McClellan Apartments

Recommendation Meeting
Updated March 21, 2013

DPD Project# 3012392

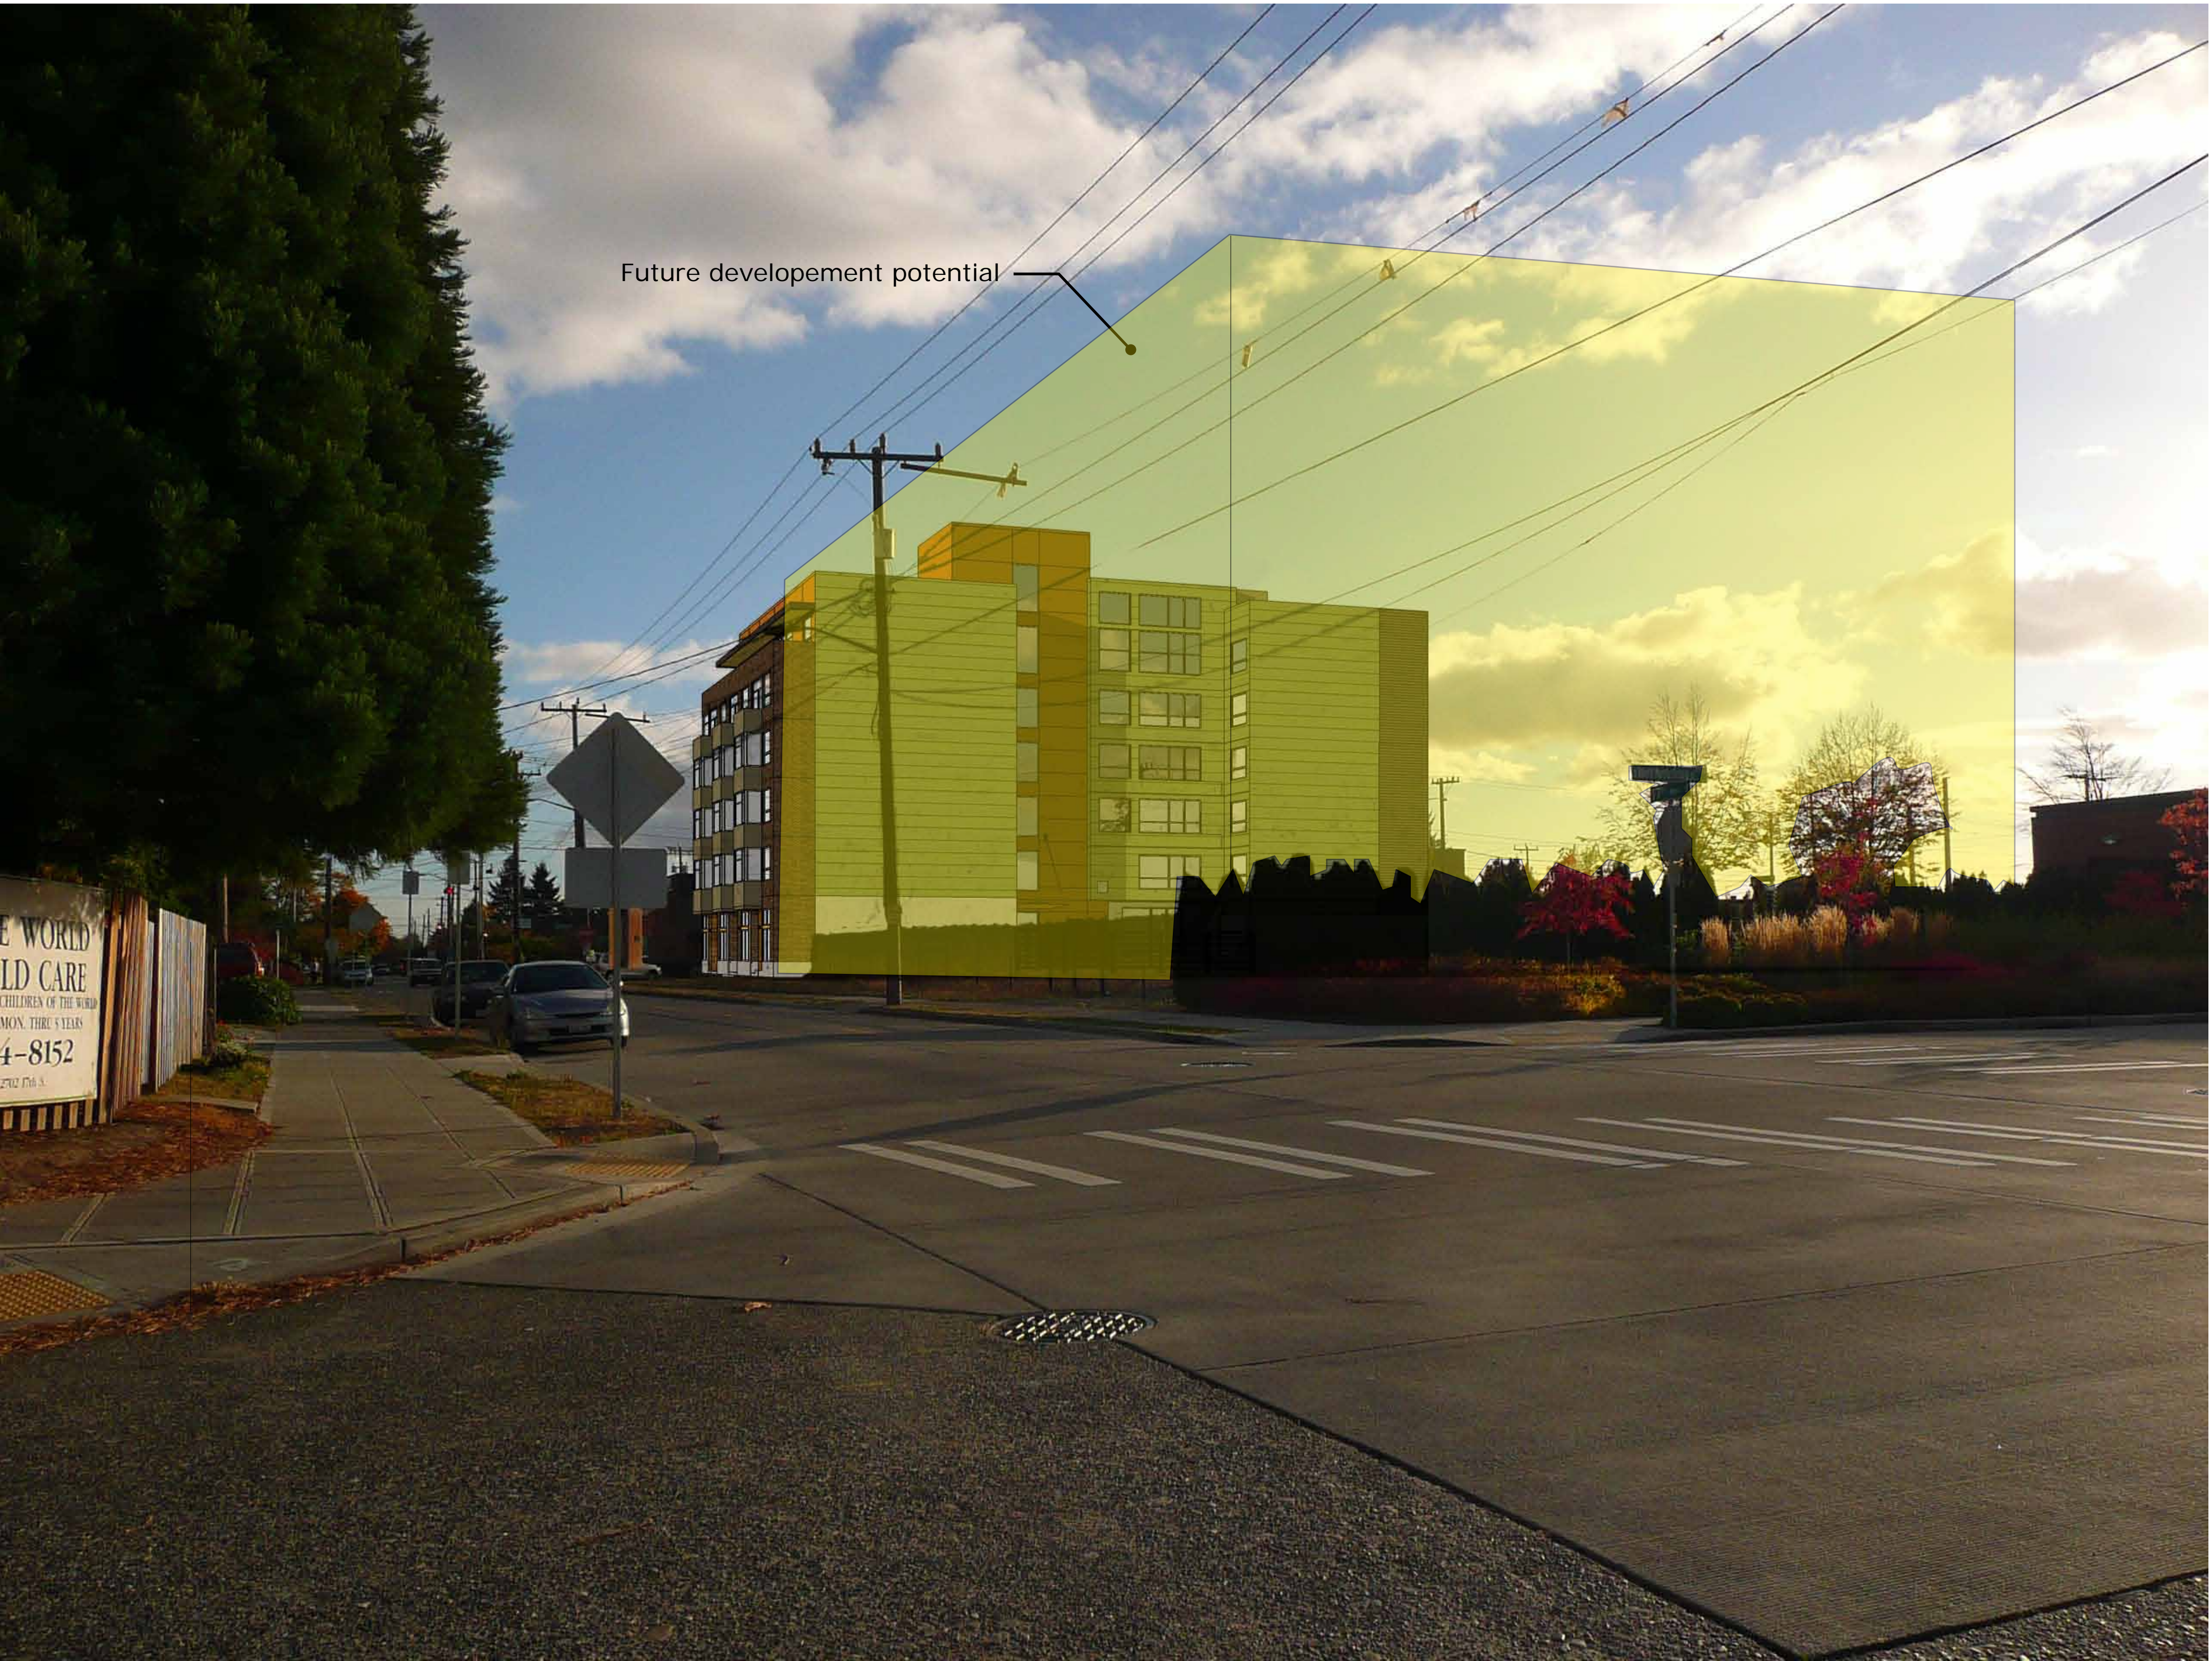
DRB Guidance

- Modulation necessary for all 4 sides of building
- Upper level setback along 17th endorsed to lessen appearance of height, bulk and scale

Response

- 6th floor set back from 17th to respond to residential scale
- Bay windows at 17th extend to 4th floor to create another set-back layer
- North facade with setback above courtyard space and changes in materials to break up scale

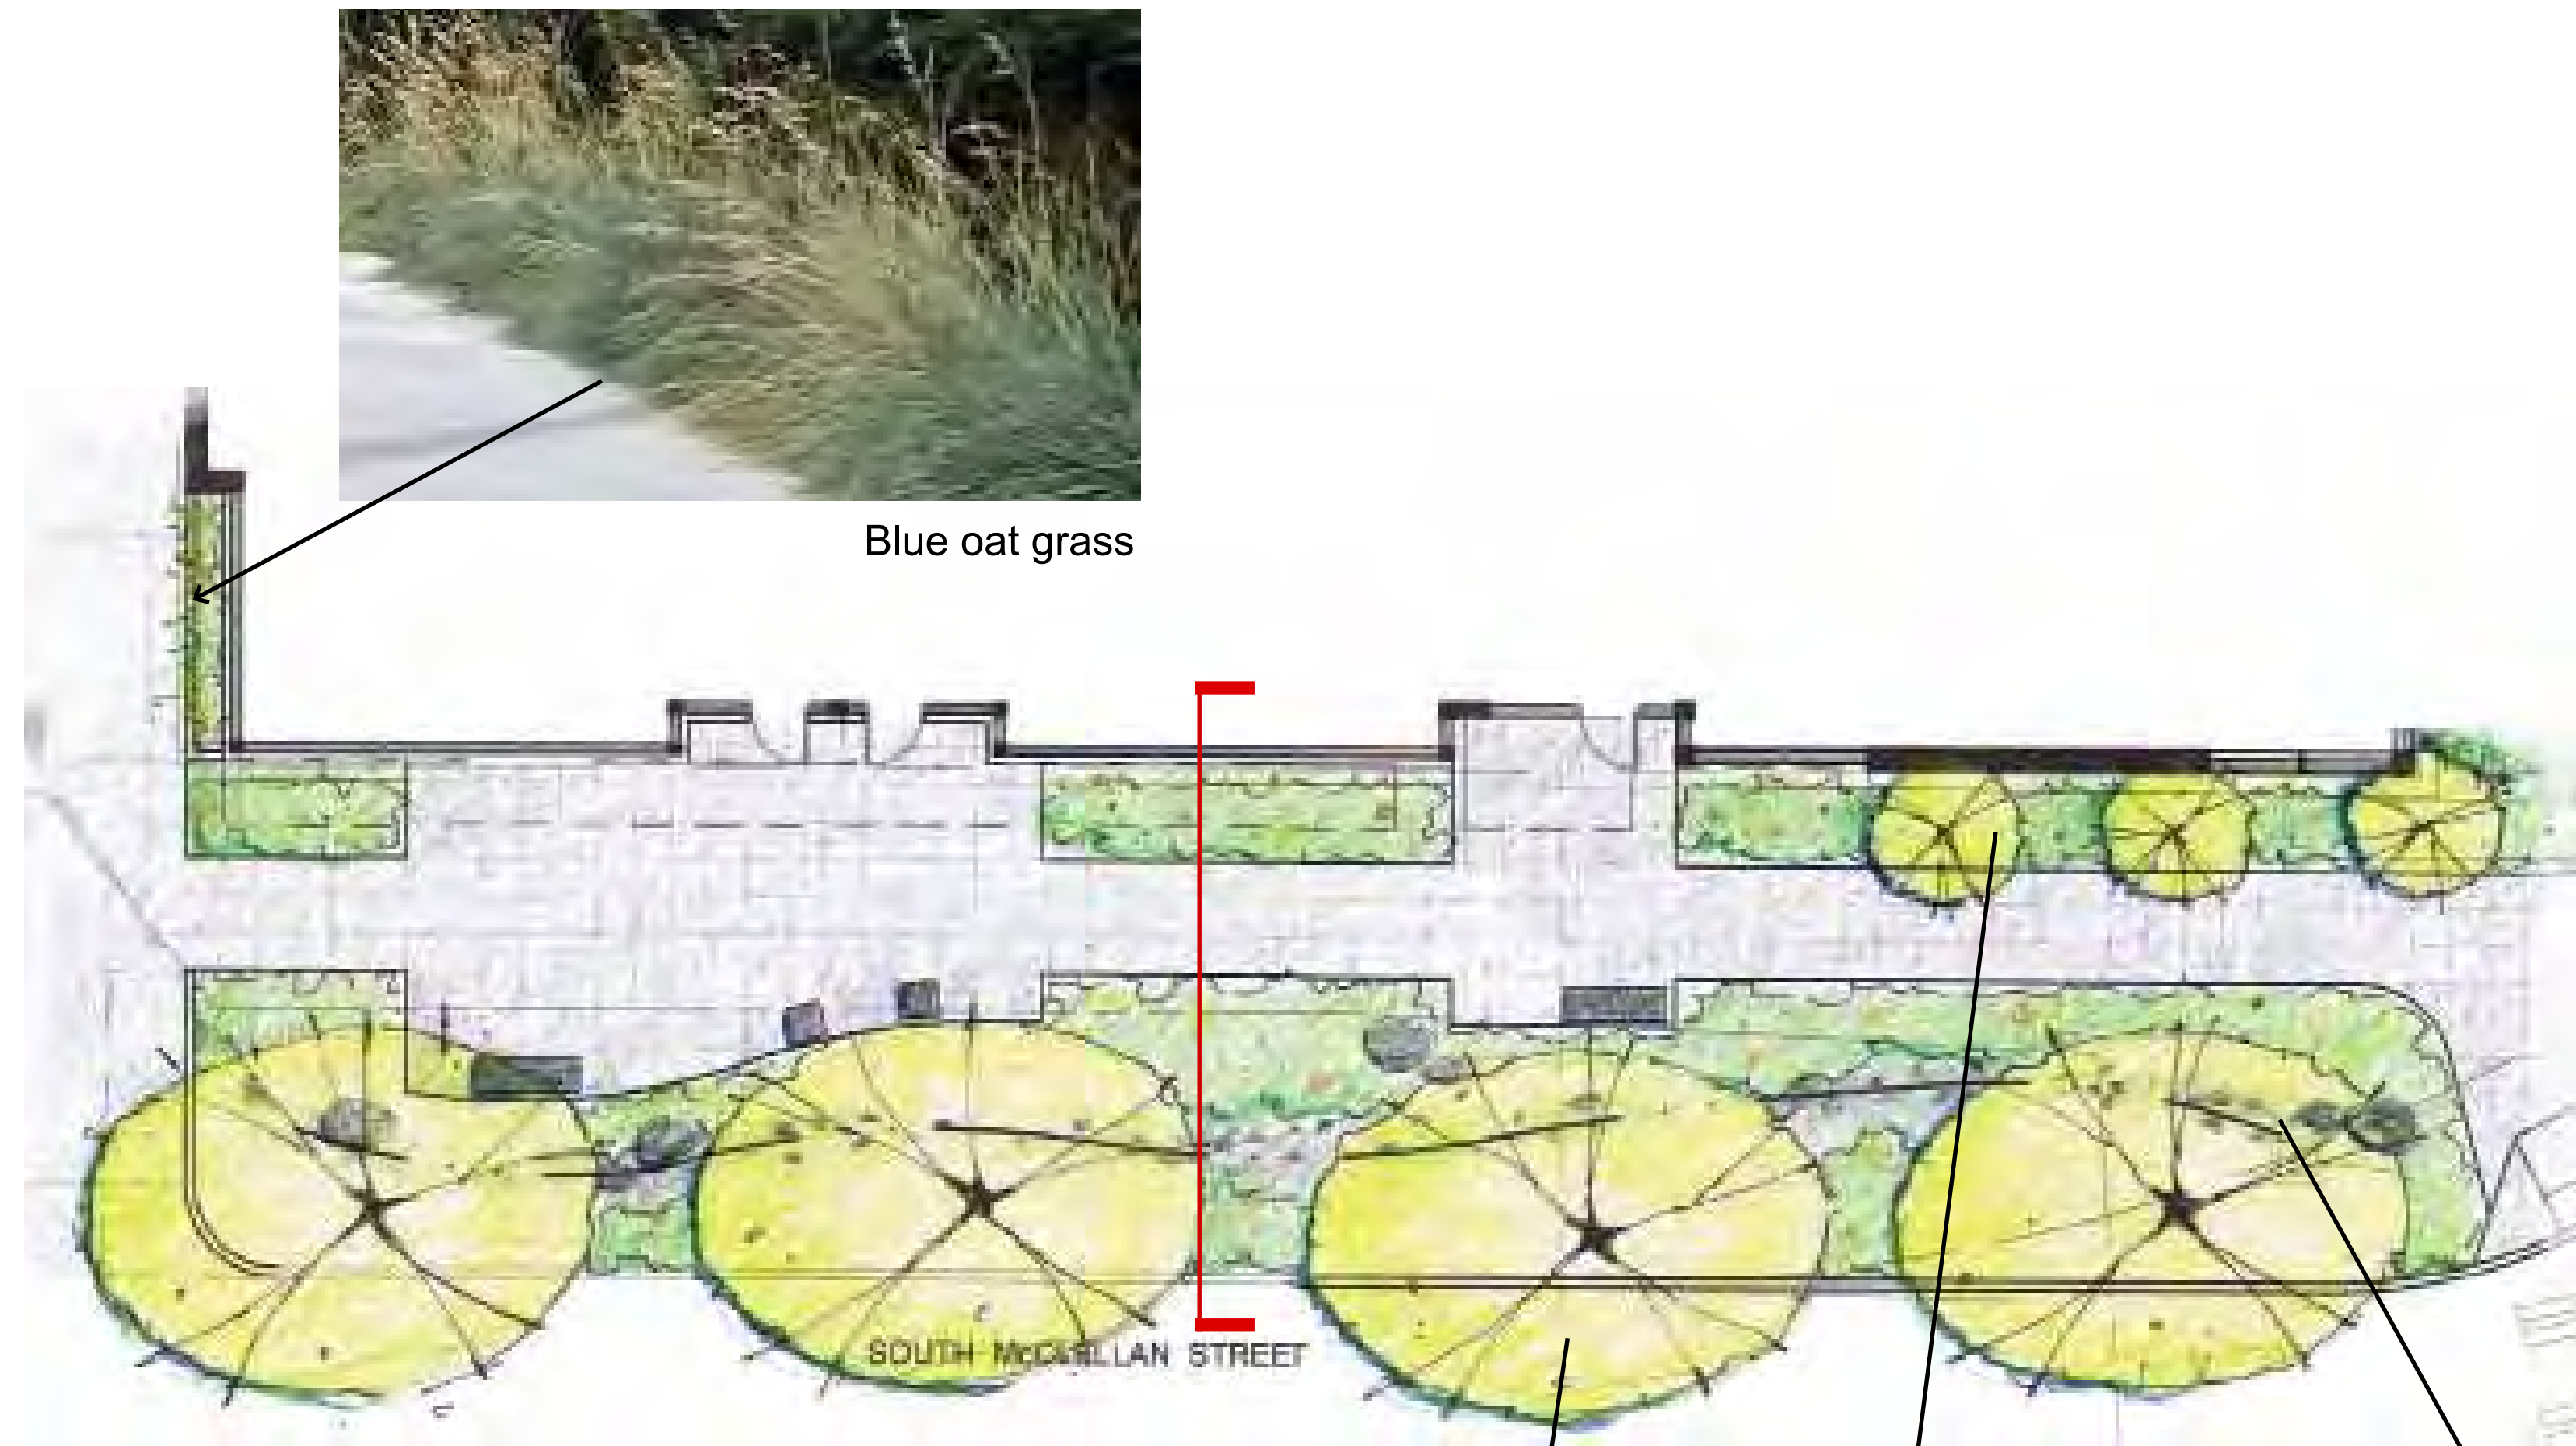
DRB Guidance

- Main residential entry should be clearly visible and identifiable

Response

- Main entry at McClellan expressed by recess that continues to top of building, creates 2 distinct masses that break down the building's scale
- Main entry emphasized with warm wood siding, integrated lighting, distinct metal canopy

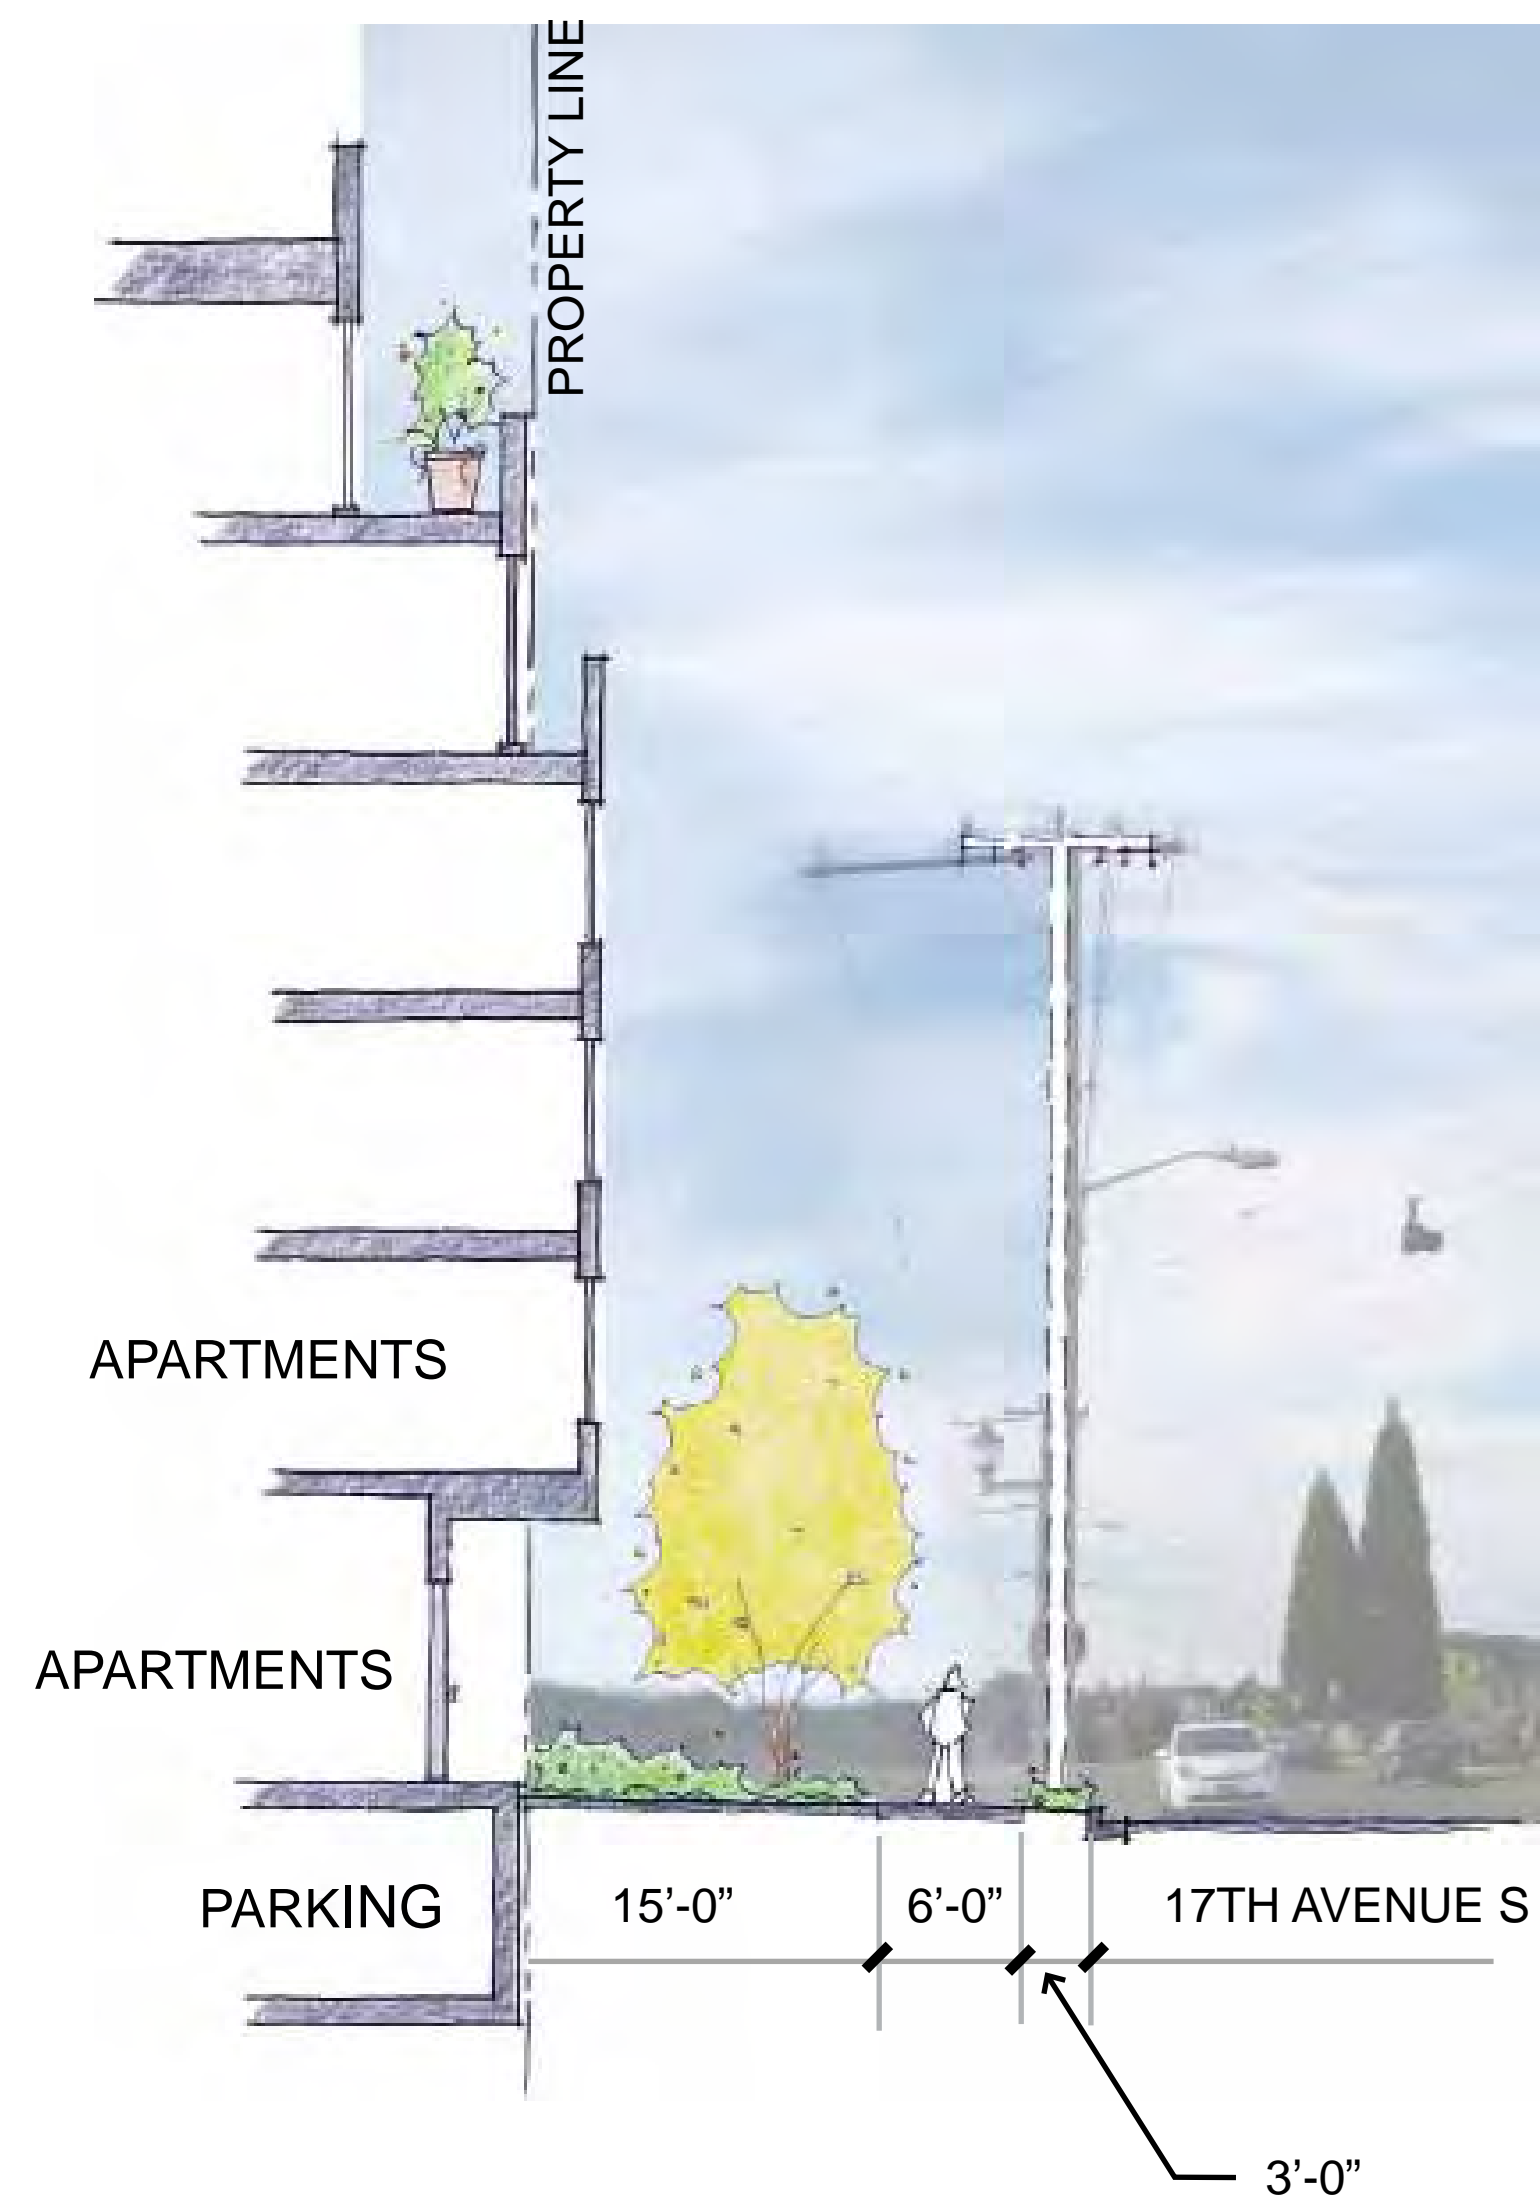
- Design Review Board Guidance**
- Incorporation of stoops between residential units and the street highly favored.
 - 17th entries should be recessed from and elevated from sidewalk

- DRB Guidance**
- Stoops should have identifiable entry points

- Response**
- Residential entry porches recessed and slightly raised from sidewalk level
 - Layered planting to screen from sidewalk
 - Residential porches to feature warm wood siding and integrated lighting to respond to 17th residential character and create a sense of individual apartment identity

- Response**
- Stoops along 17th slightly above grade, set back from sidewalk 10' to allow layered planting to provide screening and privacy and security while allowing interactions between residents and neighbors
